| AGENDA ITEM  | SUBMITTED BY  | PRESENTED BY                           |
|--|---|--|
| <p><b>Resolution PC2026-01R:</b> A Resolution of the Town of Severance Planning Commission approving, with conditions, a Site Plan application for Platte Valley Veterinary Clinic on real property located within the Town of Severance, Lot 5 Block 1, Scotch Pine Commercial at Timber Ridge PUD</p>  | <p>Shani Porter, Planning Director</p>                      | <p>Shani Porter, Planning Director</p> |

4. RCE Response - TOS Comments 1st review memo

**SEVERANCE PLANNING COMMISSION  
RESOLUTION NO. PC2026-01R**

## SITE PLAN

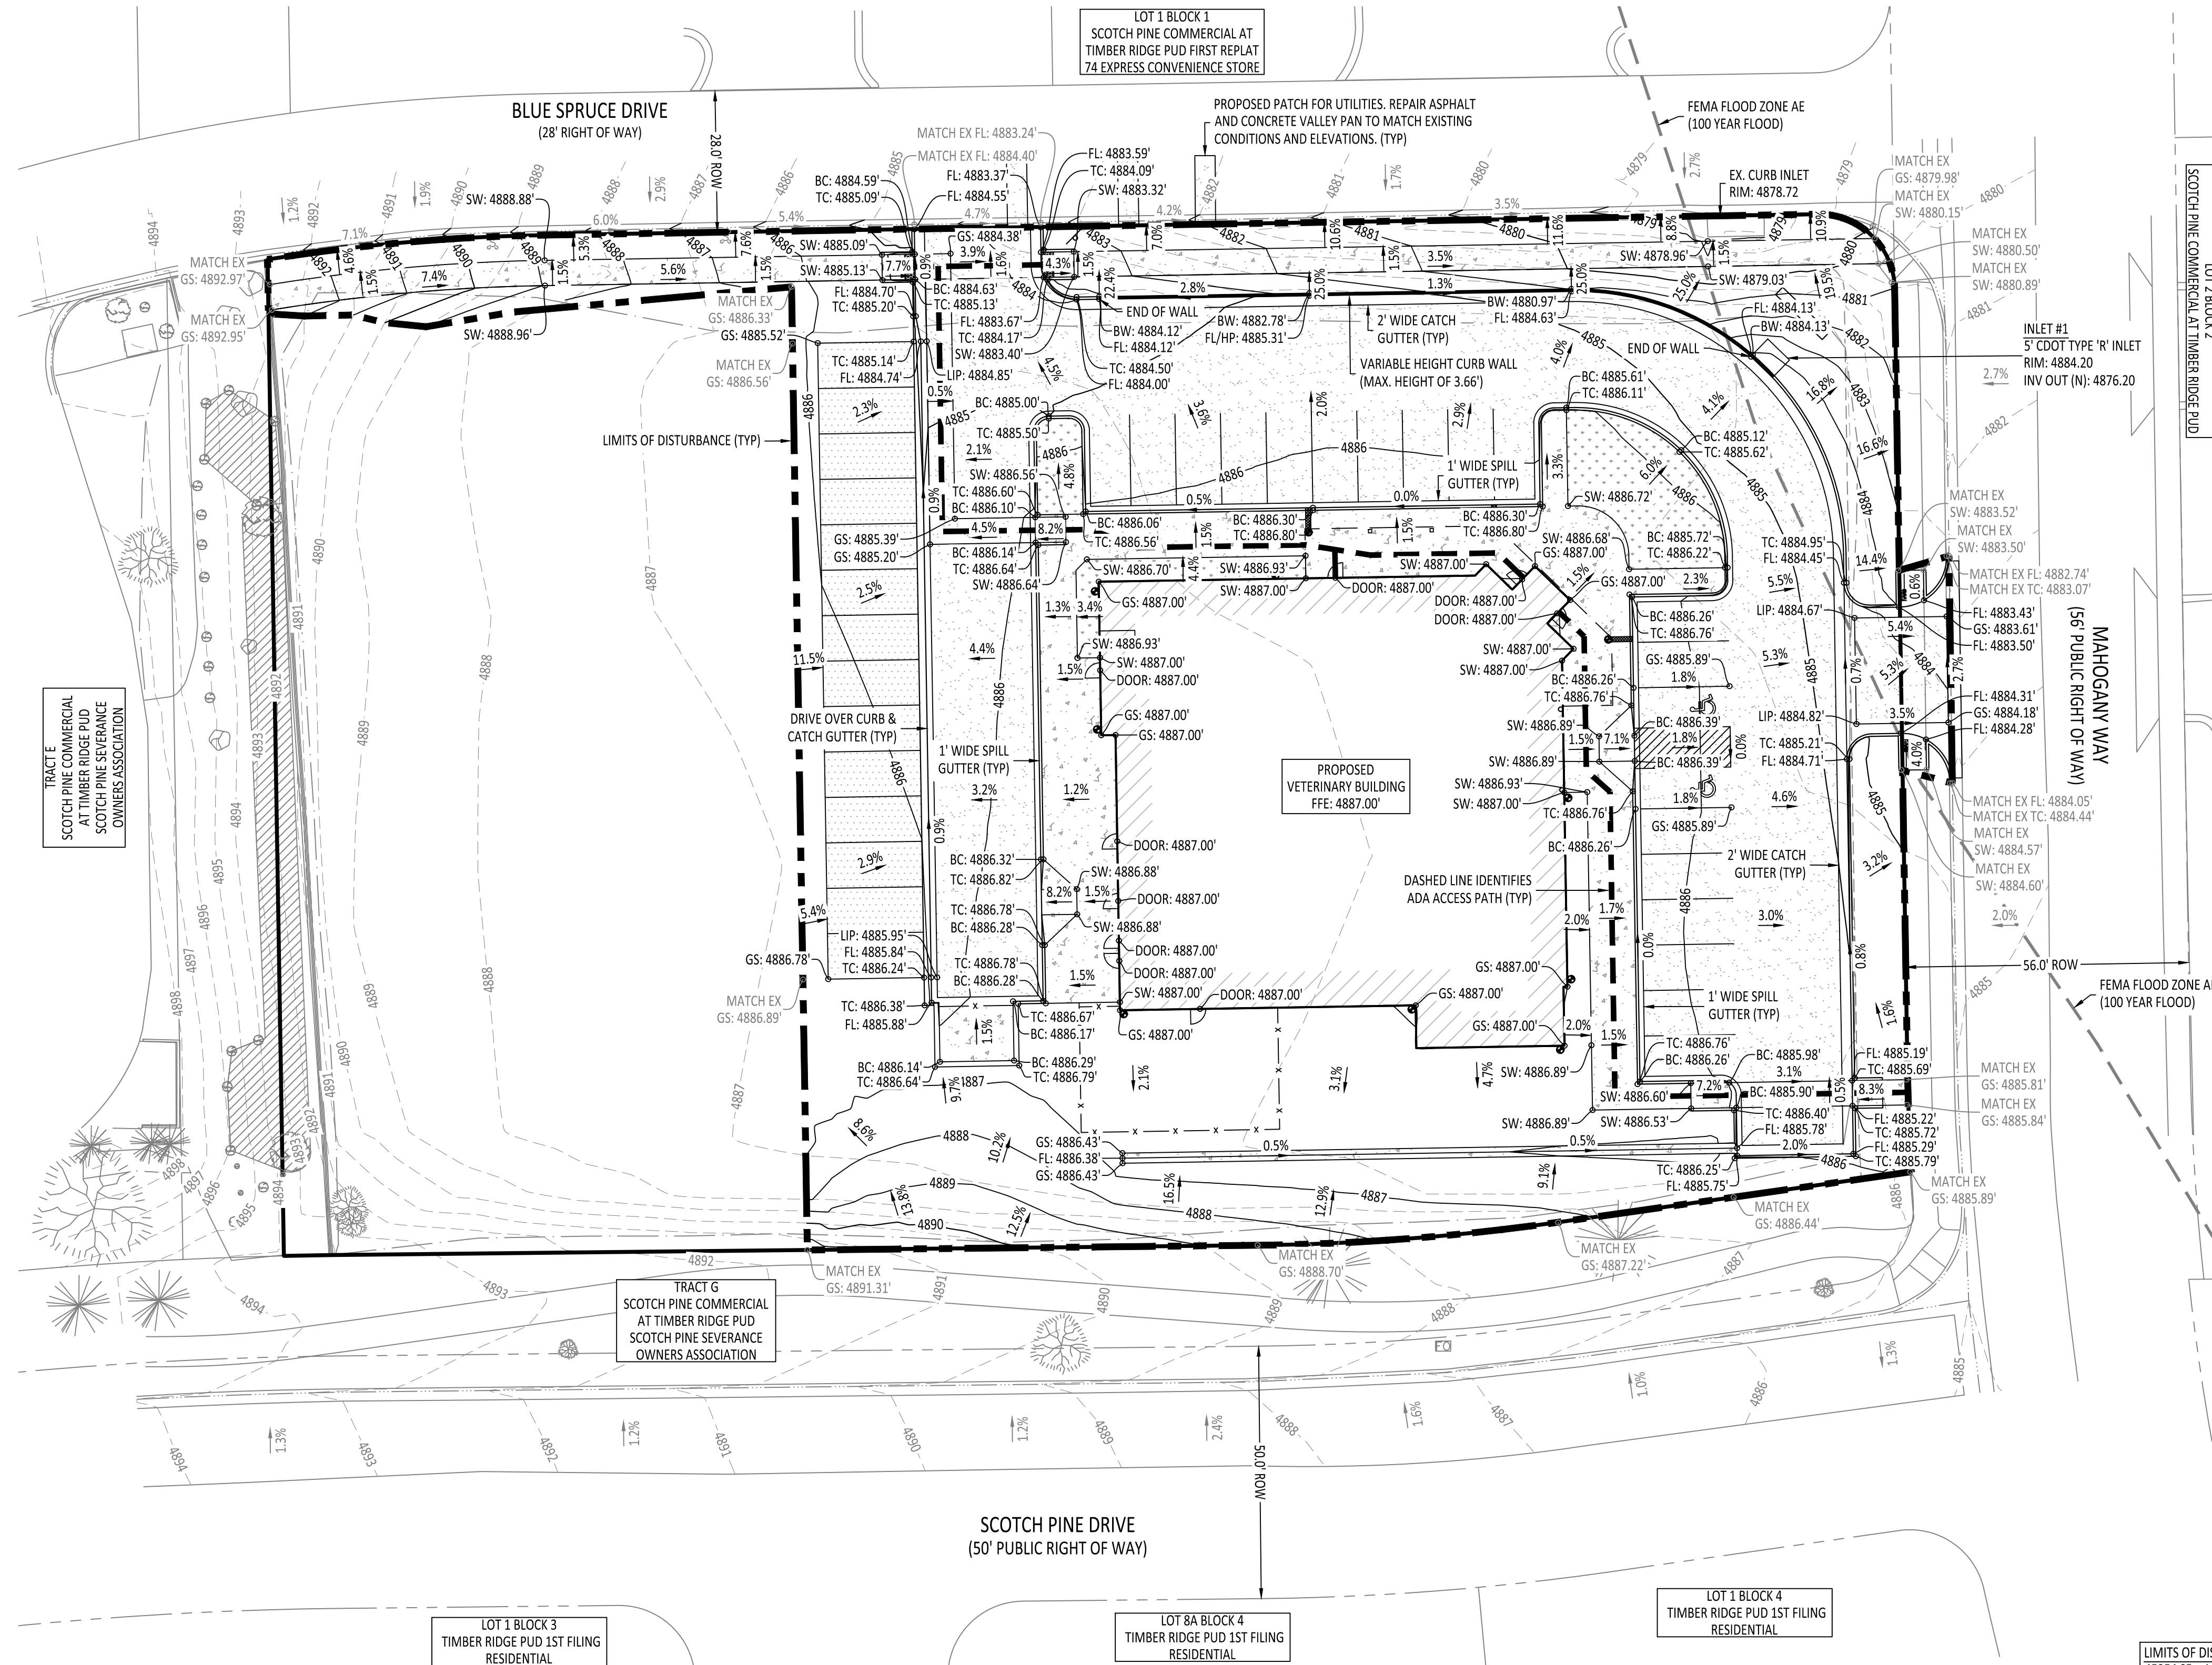
6. **Sheet 2: Site Plan (typical all sheets):** Sign specifications and placement are not shown on the site, including ADA signage and if those will be pole mounted or building mounted. Need to confirm placement and overall count throughout the site for those and other signage types. For poles, avoid pedestrian conflicts, visibility barriers, landscaping impacts.

7. **Sheet 2: Site Plan (typical all sheets):** Driveway access points need to align with properties across the street. We recommend showing this alignment on the site plan sheets.

8. **Sheet 2: Site Plan (typical all sheets):** What is planned with the western portion of the site? If the lot is planned to be split, we need to ensure all setbacks and criteria can be met on both lots individually.

9. **Sheet 2: Site Plan:** Include the parking and site details tables per the template below on this sheet.

**10. Sheet 2: Site Plan:** Required parking should align with a Clinic use at 5 parking spaces for every practitioner on staff. Confirm this in the parking table requested above. The parking spaces required shall be paved, and overflow are allowed to be aggregate but will need to be maintained. Specify on the plan sheet via notes how maintenance will be provided to avoid potholes and maintain site safety.

**11. Sheet 2: Site Plan:** The code requires that parking in the Town Core zoning designation be either located behind the building or screened with a combination of year-round landscaping, landscape screen walls, and/or earthen berms, or similar devices – Sec. 16.9.40. Given the current context of the adjacent properties, additional landscaping or screening shall be provided along the SE corner of the site, along the Scotch Pine Drive side of the east parking lot; and the wall called out along the N/NE side of the drive aisle should

**12. Sheet 2: Site Plan:** Lighten the sight triangles throughout as they take over the drawing sheet and make it difficult to clearly see the other site elements.

**13. Sheet 2: Site Plan:** Fix ADA parking space callout lead lines. They are pointing to the wrong spaces.

**14. Sheet 2: Site Plan:** A sidewalk is required along the north property line from Mahogany Way to the west end of the property.

**15. Sheet 2: Site Plan:** How will someone walk to the site? Currently, there is no designated pathway or sidewalk leading to the site from the perimeter sidewalk systems. Incorporate sidewalks into the site from the north and east driveway access points, at a minimum.

**16. Sheet 2: Site Plan (typical all sheets):** Where is mechanical equipment located such as AC units, electric panels, and other associated building or ground mounted equipment? These need to be shown on all sheets and for ground mounted equipment, they need to be clear of walkways and be incorporated into the landscaping. For building mounted, screening and painting need to be referenced in notes and callouts.

**17. Sheet 2: Site Plan (typical all sheets):** The driveway servicing deliveries and the trash enclosure needs to be paved.

**Applicant response:** Setbacks have been shown on the civil site plan. Refer to Sheet C2 for the setback callouts and linework

**Applicant response:** Site data table has been added to Sheet 1.

**Applicant response:** There will be a total of three veterinarians (practitioners) on staff. Thus, a total of 15 stalls are required. This information has been added to the site data table. A maintenance note has been added to Sheet 2 in the "Site Notes" section.

**Applicant response:** A sidewalk has been added to connect the Mahogany Way sidewalk to the site. Additionally, an ADA path has been indicated to connect the newly installed Blue Spruce Drive sidewalk to the site. These sidewalks and pathways have been identified on Sheet 2 with the dashed line ADA route.

**Applicant response:** The mechanical equipment is now shown on the architectural site plan. Refer to sheet A-1 for a depiction of the mechanical equipment.

## LANDSCAPE PLAN

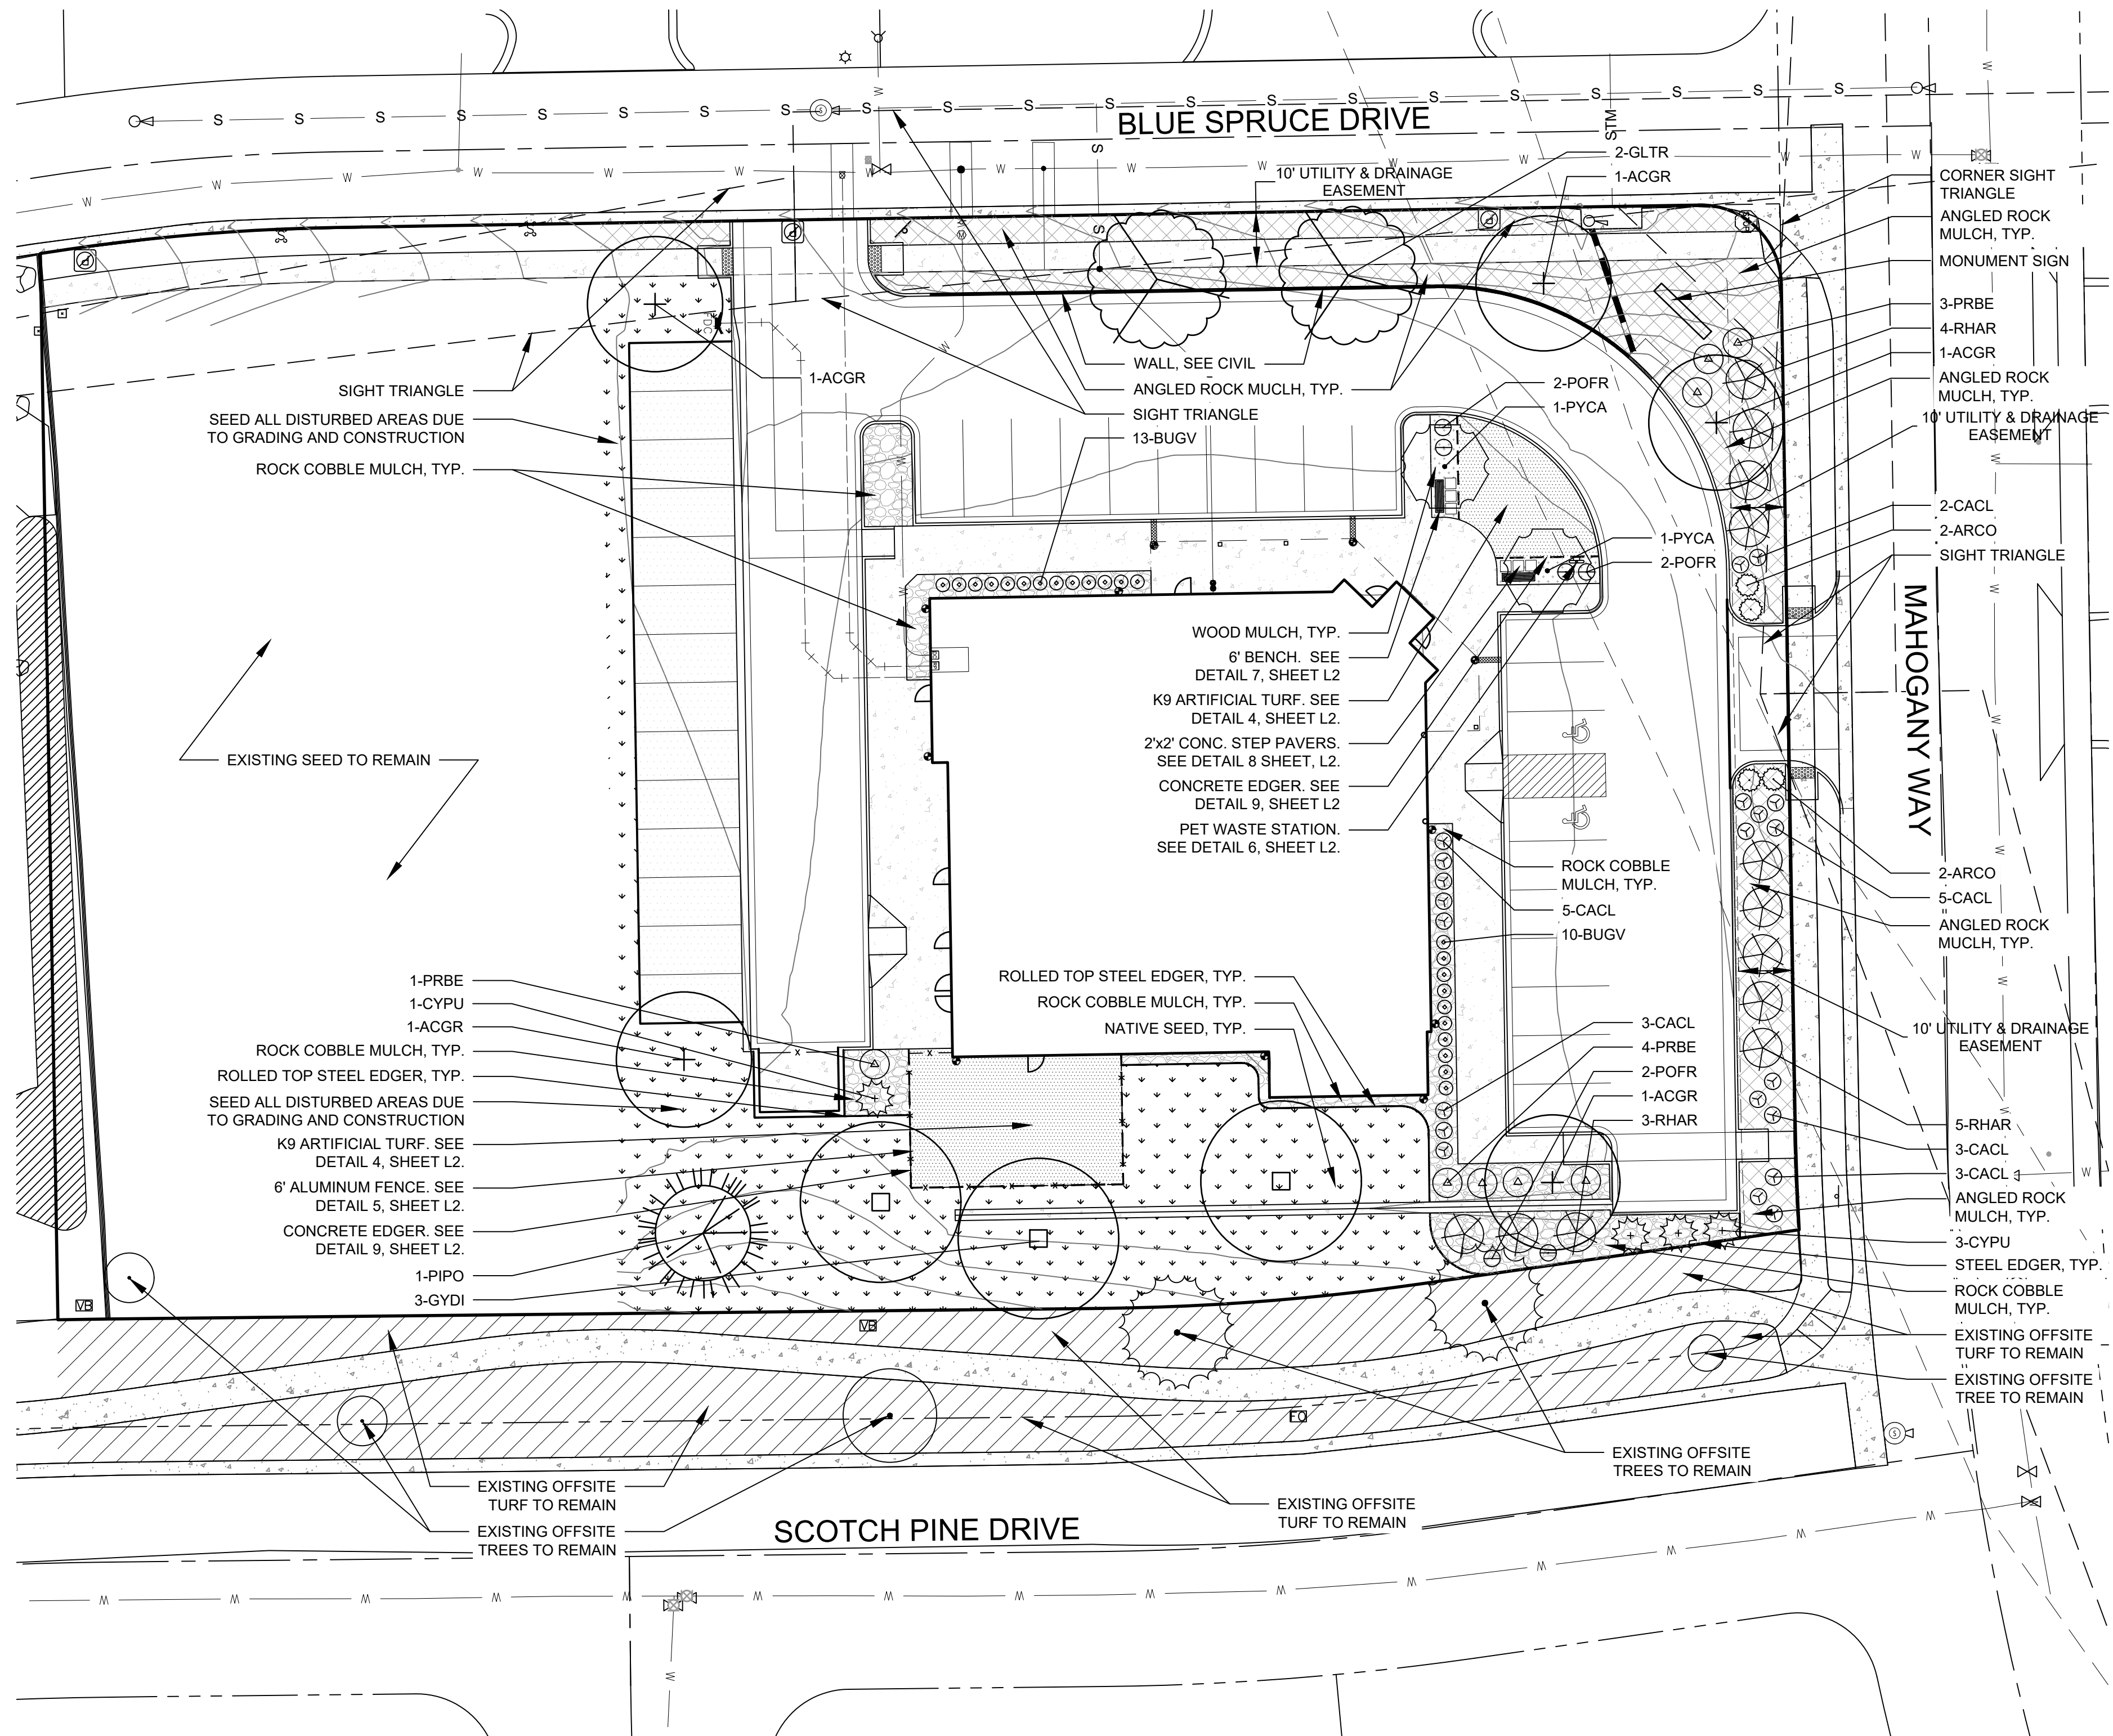
- 22. Sheet 8: Landscape Plan:** How does angled rock hold up on slopes, particularly on the north/northeast edge of the site? We want to ensure rock mulch does not slide down hills and around sites over time.

- 23. Sheet 8: Landscape Plan:** Revise tree placement due to Engineering comments with these being shown in utility easements. Tree shade next to the K9 Artificial Turf area would be a nice addition to help shade the space and adjacent parking areas.

- 24. Sheet 8: Landscape Plan:** Shade trees should be incorporated in the island extensions and adjacent to parking areas, where practical and in spaces wide

**25. Sheet 8: Landscape Plan:** Ensure minimum plant sizes in the table meet code, installation should ensure this as well. (2-inch caliper deciduous, 1 ½ inch caliper ornamental, six-foot-tall evergreens, and five-gallon sized container for shrub and ornamental grasses – unless otherwise specified by the Tree Board.

**26. Sheet 8: Landscape Plan:** Minimum landscaping requirements for non-residential uses include the following:
